ROCKY FLATS ENVIRONMENTAL TECHNOLOGY SITE ER REGULATORY CONTACT RECORD

Purpose of Contact Finalize language in revised SAP for 903 Lip area

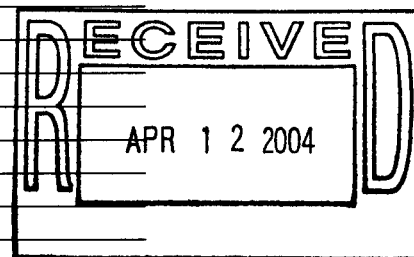
- 1 Remediation work in the southern portion of the inner lip (kriging area) will be sequenced to minimize safety issues of personnel and heavy equipment working on sloped areas. This will typically include a down-slope or cross-slope work sequence.
- 2 Confirmation samples will be collected and analyzed on a daily basis.
- 3 Confirmation samples will be as shown on the Figure 5 in the revised SAP.
- 4 All confirmation sample points will be labeled for work tracking.
- 5 Confirmation samples that exceed the 50 pCi/g Pu (calculated) will be re-excavated in a 42'x42' square area as shown on Figure 5 in the revised SAP. Confirmation samples immediately adjacent to the limits of remediation may consist of a partial 42'x42' square.
